S8JX-P Series Replacement Brackets

Original model mounting method	Replacement model: S8JX-P	Replacement model: S8FS-G	Replacement bracket	
	Models no longer available to order (except for the S8JX-P300/600)	Recommended replacement model	Model	Page
Bottom mounting	S8JX-P050□□	S8FS-G050□□	S82Y-FSG-B02	page 2
	S8JX-P100□□	S8FS-G100□□	S82Y-FSG-B03	page 3
	S8JX-P150□□	S8FS-G150□□	S82Y-FSG-B04	page 4
	S8JX-P300□□	S8FS-G300□□	S82Y-FSG-B05	page 5
	S8JX-P600□□	S8FS-G600□□	S82Y-FSG-B07	page 6
Front mounting	S8JX-P050□□	S8FS-G050□□	S82Y-FSG-F31	page 7
	S8JX-P100□□	S8FS-G100□□	S82Y-FSG-F32	page 8
	S8JX-P150□□	S8FS-G150□□		
	S8JX-P300□□	S8FS-G300□□	S82Y-FSG-F36	page 9
	S8JX-P600□□	S8FS-G600□□	S82Y-FSG-F38	page 10
Side mounting	S8JX-P050□□	S8FS-G050□□	S82Y-FSG-S22	page 11
	S8JX-P100□□	S8FS-G100□□	S82Y-FSG-S23	page 12
	S8JX-P150□□	S8FS-G150□□	S82Y-FSG-S24	page 13
	S8JX-P300□□	S8FS-G300□□	S82Y-FSG-S25	page 14
	S8JX-P600□□	S8FS-G600□□	S82Y-FSG-S26	page 15

S8JX-P050 □ □

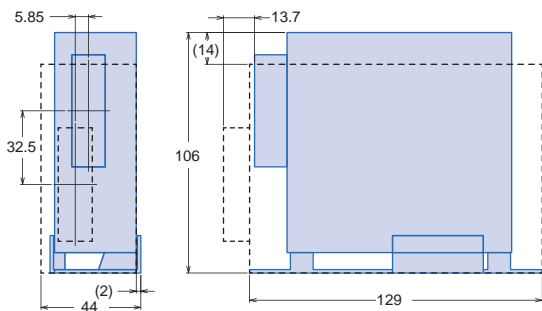
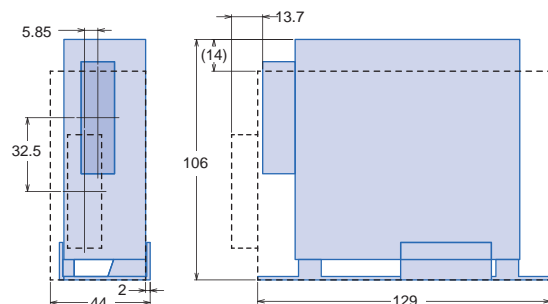
Mounting dimension differences before/after replacement

■ S8FS-G + Replacement bracket, □ S8JX-P Series

Mounting using replacement bracket mounting holes	Mounting using replacement bracket screw holes
Processing dimensions	<p>M3 120±0.2</p>	<p>3.5 dia. 86±0.2</p>
Mounting Method	<p>(1) (2)</p> <p>Included screws Recommended tightening torque M3 : 0.54 N·m</p> <p>Note: The figure above shows the mounting direction for S82Y-FSG-B01, a similar product. The shape of S82Y-FSG-B02 will be slightly different.</p>	<p>(1) (2)</p> <p>Included screws Recommended tightening torque M3 : 0.54 N·m</p> <p>Note: 1. The figure above shows the mounting direction for S82Y-FSG-B01, a similar product. The shape of S82Y-FSG-B02 will be slightly different. 2. Be cautious of the length of the screws being used to avoid interference with the power supply unit.</p>

S8JX-P100□□

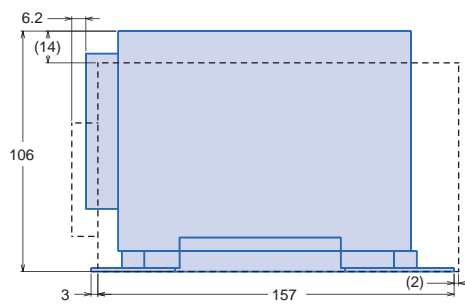
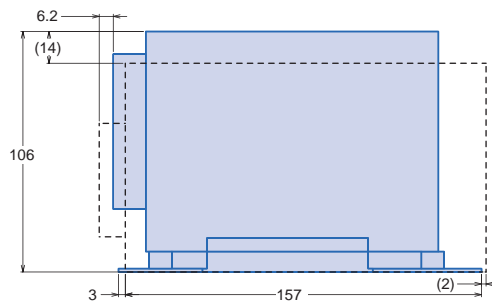
Mounting dimension differences before/after replacement

■ S8FS-G + Replacement bracket, □ S8JX-P Series

Mounting using replacement bracket mounting holes	Mounting using replacement bracket screw holes
Processing dimensions		
Mounting Method	<p>Note: The figure above shows the mounting direction for S82Y-FSG-B01, a similar product. The shape of S82Y-FSG-B03 will be slightly different.</p>	<p>Note: 1. The figure above shows the mounting direction for S82Y-FSG-B01, a similar product. The shape of S82Y-FSG-B03 will be slightly different. 2. Be cautious of the length of the screws being used to avoid interference with the power supply unit.</p>

S8JX-P150 □ □

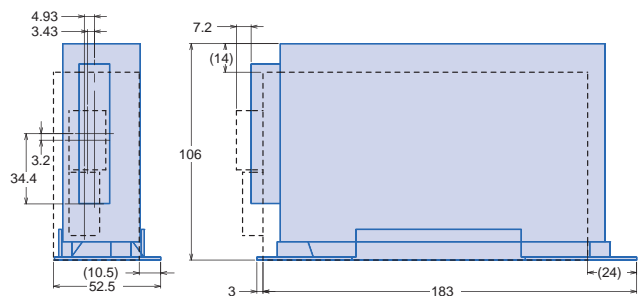
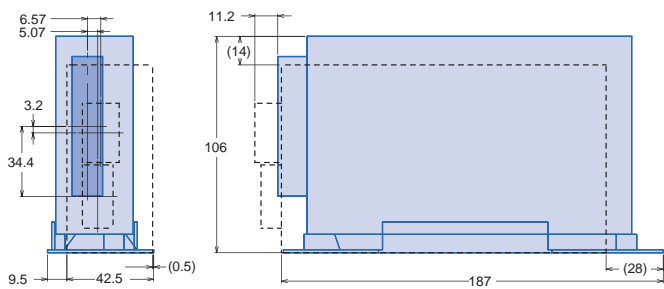
Mounting dimension differences before/after replacement

■ S8FS-G + Replacement bracket, □ S8JX-P Series

Mounting using replacement bracket mounting holes	Mounting using replacement bracket screw holes
Processing dimensions	<p>M3 150±0.2</p>	<p>3.5 dia. 98±0.2</p>
Mounting Method	<p>(1) (2) Included screws Recommended tightening torque M3 : 0.54 N·m</p> <p>Note: The figure above shows the mounting direction for S82Y-FSG-B01, a similar product. The shape of S82Y-FSG-B04 will be slightly different.</p>	<p>(1) (2) Included screws Recommended tightening torque M3 : 0.54 N·m</p> <p>Note: 1. The figure above shows the mounting direction for S82Y-FSG-B01, a similar product. The shape of S82Y-FSG-B04 will be slightly different. 2. Be cautious of the length of the screws being used to avoid interference with the power supply unit.</p>

S8JX-P300 □ □

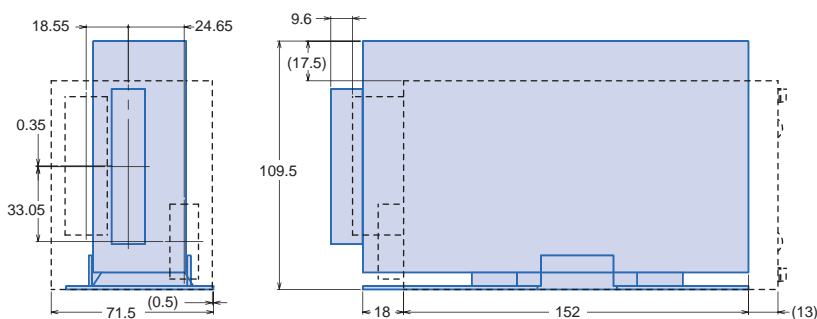
Mounting dimension differences before/after replacement

■ S8FS-G + Replacement bracket, □ S8JX-P Series

Mounting using replacement bracket screw holes	
Processing dimensions	<p>4.5 dia. 120 ± 0.2 35 ± 0.2</p>
Mounting Method	<p>(1) Included screws (2) Recommended tightening torque M4 : 1.2 N·m</p> <p>Note: 1. The figure above shows the mounting direction for S82Y-FSG-B01, a similar product. The shape of S82Y-FSG-B05 will be slightly different. 2. Be cautious of the length of the screws being used to avoid interference with the power supply unit.</p>

S8JX-P600 □ □

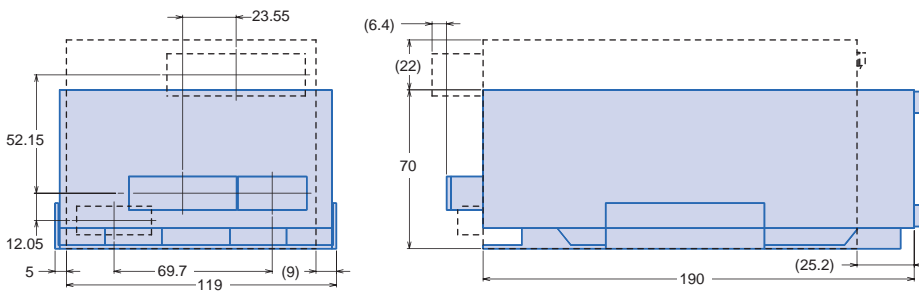
Mounting dimension differences before/after replacement

S8FS-G + Replacement bracket,
 S8JX-P Series

Mounting using replacement bracket screw holes	
Processing dimensions	
Mounting Method	<p style="text-align: center;">Recommended tightening torque M4 : 1.2 N·m</p> <p style="text-align: center;">Included screws</p> <p>Note: Be cautious of the length of the screws being used to avoid interference with the power supply unit.</p>

S8JX-P050□□

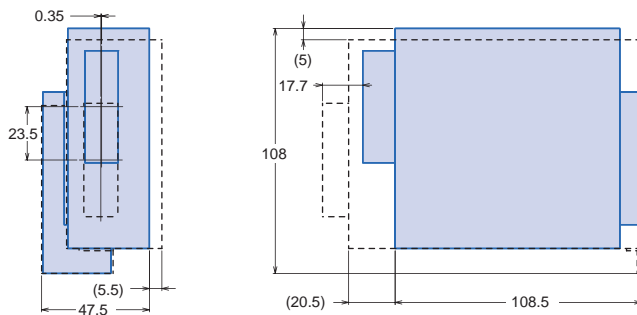
Mounting dimension differences before/after replacement

S8FS-G + Replacement bracket,
 S8JX-P Series

Mounting using replacement bracket mounting holes	
Processing dimensions	
Mounting Method	<p>Recommended tightening torque M3 : 0.54 N·m</p> <p>Note: The figure above shows the mounting direction for S82Y-FSG-F32, a similar product. The shape of S82Y-FSG-F31 will be slightly different.</p>

S8JX-P100 □ □

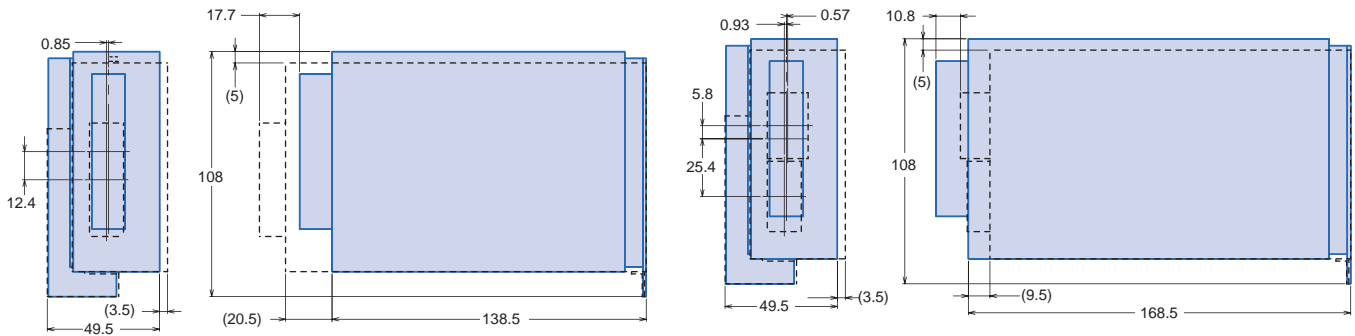
Mounting dimension differences before/after replacement

■ S8FS-G + Replacement bracket, □ S8JX-P Series

Mounting using replacement bracket mounting holes	
Processing dimensions	
Mounting Method	<p>Recommended tightening torque M3 : 0.54 N·m</p>

S8JX-P300 □□

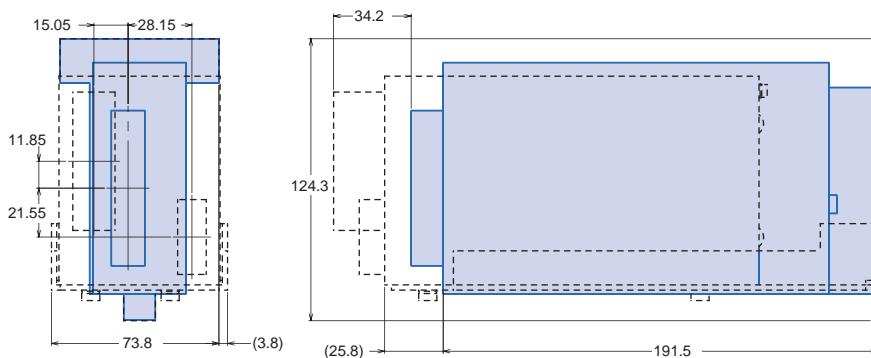
Mounting dimension differences before/after replacement

S8FS-G + Replacement bracket,
 S8JX-P Series

Mounting using replacement bracket mounting holes	
Processing dimensions	
Mounting Method	<p>Note: The figure above shows the mounting direction for S82Y-FSG-F37, a similar product. The shape of S82Y-FSG-F36 will be slightly different.</p>

S8JX-P600□□

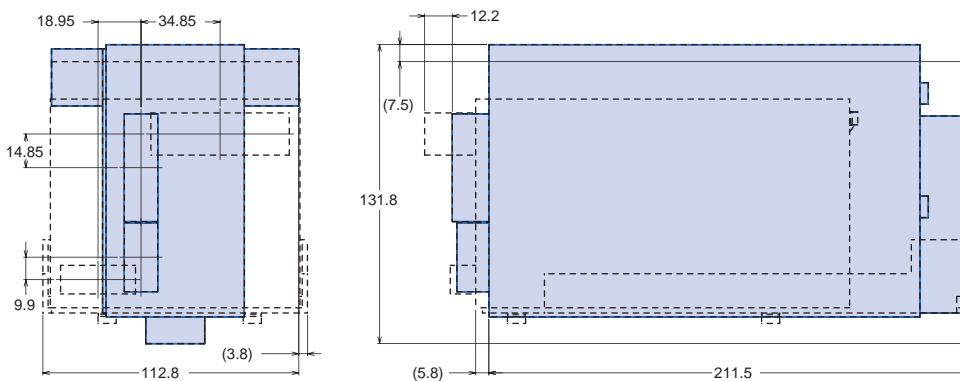
Mounting dimension differences before/after replacement

■ S8FS-G + Replacement bracket, □ S8JX-P Series

Note: The figure above shows the mounting direction for S82Y-FSG-F37, a similar product. The shape of S82Y-FSG-F38 will be slightly different.

S8JX-P050 □ □

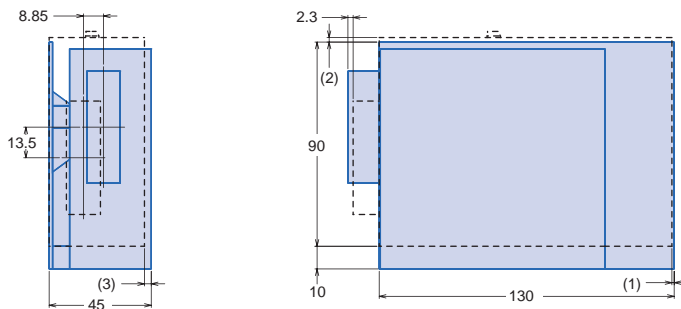
Mounting dimension differences before/after replacement

S8FS-G + Replacement bracket,
 S8JX-P Series

Mounting using replacement bracket mounting holes	
Processing dimensions	
Mounting Method

S8JX-P100 □ □

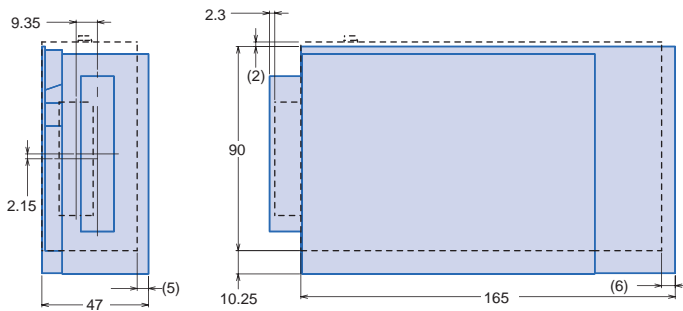
Mounting dimension differences before/after replacement

■ S8FS-G + Replacement bracket, □ S8JX-P Series

Mounting using replacement bracket mounting holes	
Processing dimensions	
Mounting Method	<p>Note: The figure above shows the mounting direction for S82Y-FSG-S22, a similar product. The shape of S82Y-FSG-S23 will be slightly different.</p>

S8JX-P150 □ □

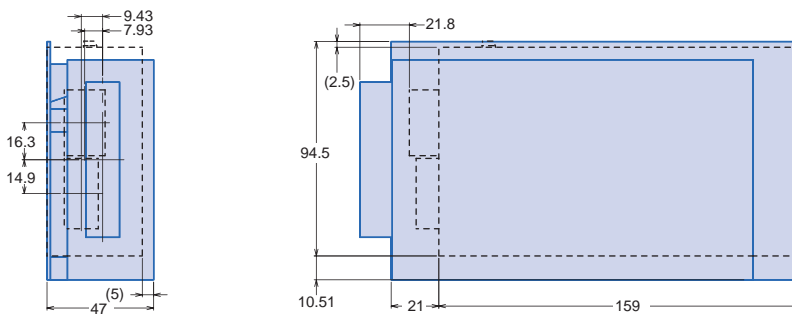
Mounting dimension differences before/after replacement

■ S8FS-G + Replacement bracket, □ S8JX-P Series

Mounting using replacement bracket mounting holes	
Processing dimensions	
Mounting Method	<p>Recommended tightening torque M3 : 0.54 N·m</p> <p>Included screws</p> <p>Note: The figure above shows the mounting direction for S82Y-FSG-S22, a similar product. The shape of S82Y-FSG-S24 will be slightly different.</p>

S8JX-P300 □ □

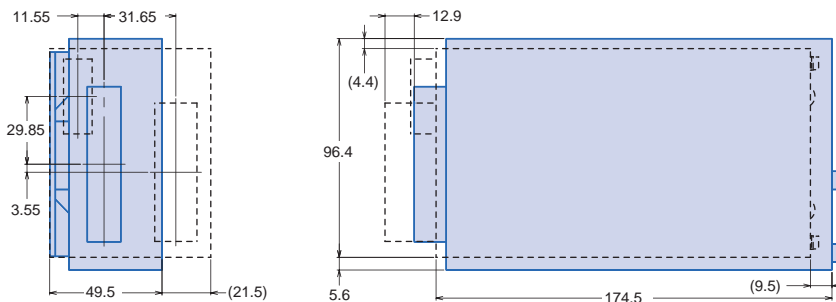
Mounting dimension differences before/after replacement

■ S8FS-G + Replacement bracket, □ S8JX-P Series

Mounting using replacement bracket screw holes	
Processing dimensions	
Mounting Method	<div style="display: flex; justify-content: space-around;"> <div style="text-align: center;"> <p>(1)</p> <p>Included screws</p> </div> <div style="text-align: center;"> <p>(2)</p> <p>Recommended tightening torque M4 : 1.2 N·m</p> </div> </div> <p>Note: 1. The figure above shows the mounting direction for S82Y-FSG-S22, a similar product. The shape of S82Y-FSG-S25 will be slightly different. Note: 2. Be cautious of the length of the screws being used to avoid interference with the power supply unit.</p>

S8JX-P600 □ □

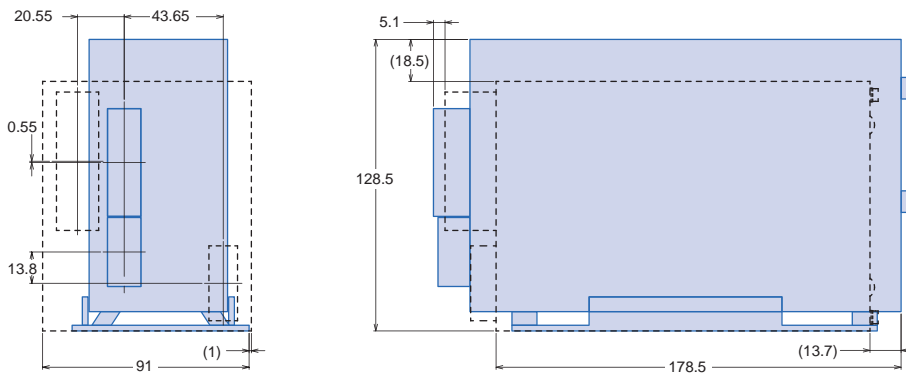
Mounting dimension differences before/after replacement

■ S8FS-G + Replacement bracket, □ S8JX-P Series

Mounting using replacement bracket screw holes	
Processing dimensions	<p>Diagram showing the processing dimensions for the replacement bracket screw holes. The dimensions are 125 ± 0.2 mm in width and 50 ± 0.2 mm in height. The holes have a diameter of 4.5 mm.</p>
Mounting Method	<p>Diagram illustrating the mounting method in two steps: (1) The replacement bracket is positioned below the device. (2) The bracket is attached to the device using the included screws. Recommended tightening torque for M4 screws is 1.2 N·m.</p> <p>Note: Be cautious of the length of the screws being used to avoid interference with the power supply unit.</p>
